Work Order ID 162008

Item ID: D407-667-105 Accept ***N900040100*** Setup Start ***NS1***
Revision ID: Stop ***NS2***
Item Name: Fwd Crosstube - High 407
Start Date: 6/8/2017 Start Qty: 1.00 ***1*** Cust Item ID:
Required Date: 6/22/2017 Req'd Qty: 1.00 ***1*** Customer:
Reference:

DART AEROSPACE LTD	Work Order: 162008
Description: Crosstube High Fwd (407)	Part Number: D407-667-105
Inspection Dwg: D407-667-145 Rev: C	Page 1 of 1

DRAWING NO. D407-667-145	TITLE CROSSTUBE ASS'Y (407 HIGH FWD)	REV. C	DART AEROSPACE LTD ENGINEERING ORDER		D.E.O. NO. D407-667-145-C-1	SHEET NO. SHEET 1 OF 1	SCALE NTS
DRAWN 90	CHECKED ASS		MFG. APPR. [Signature]	APPROVED [Signature]		DE APPR. [Signature]	
DATE 11.07.15	DATE 11.07.22		DATE 11.07.22	DATE 11.07.22		DATE 11.07.21

DRAWING NO. D407-667-145	TITLE CROSSTUBE ASS'Y (407 HIGH FWD)	REV. C	DART AEROSPACE LTD ENGINEERING ORDER		D.E.O. NO. D407-667-145-C-2	SHEET NO. SHEET 1 OF 1	SCALE NTS
DRAWN AJS	CHECKED	MFG. APPR.	APPROVED		DE APPR.		
DATE 12.08.02	DATE 12.08.02	DATE 12.08.02	DATE 12.08.02		DATE 12.08.02

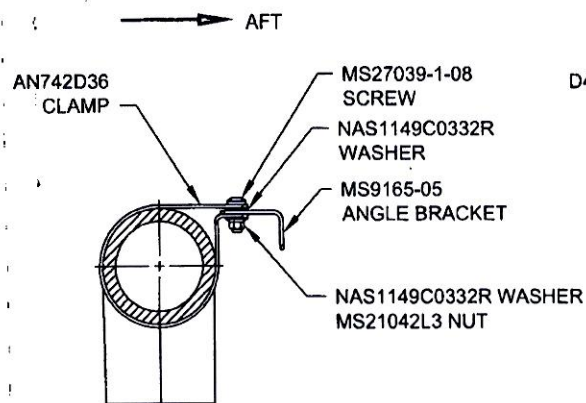
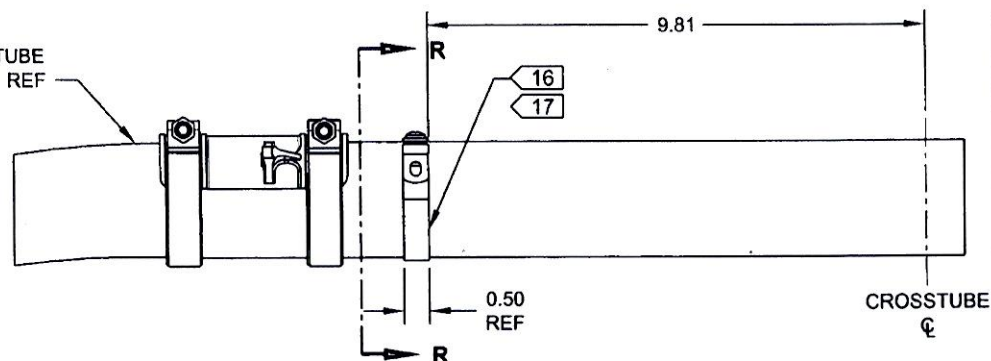
PURPOSE:

ADD ELECTRICAL GROUNDING STRAP

ITEM	QTY	PART NUMBER	DESCRIPTION
1	X	D407-667-145	CROSSTUBE ASSEMBLY (407 HIGH FWD)
10	2	AN742D36	CLAMP
11	2	MS9165-05	ANGLE BRACKET
12	2	MS21042L3	NUT (OR MS21042-3)
13	2	MS27039-1-08	SCREW
14	4	NAS1149C0332R	WASHER (OR AN960C10L)
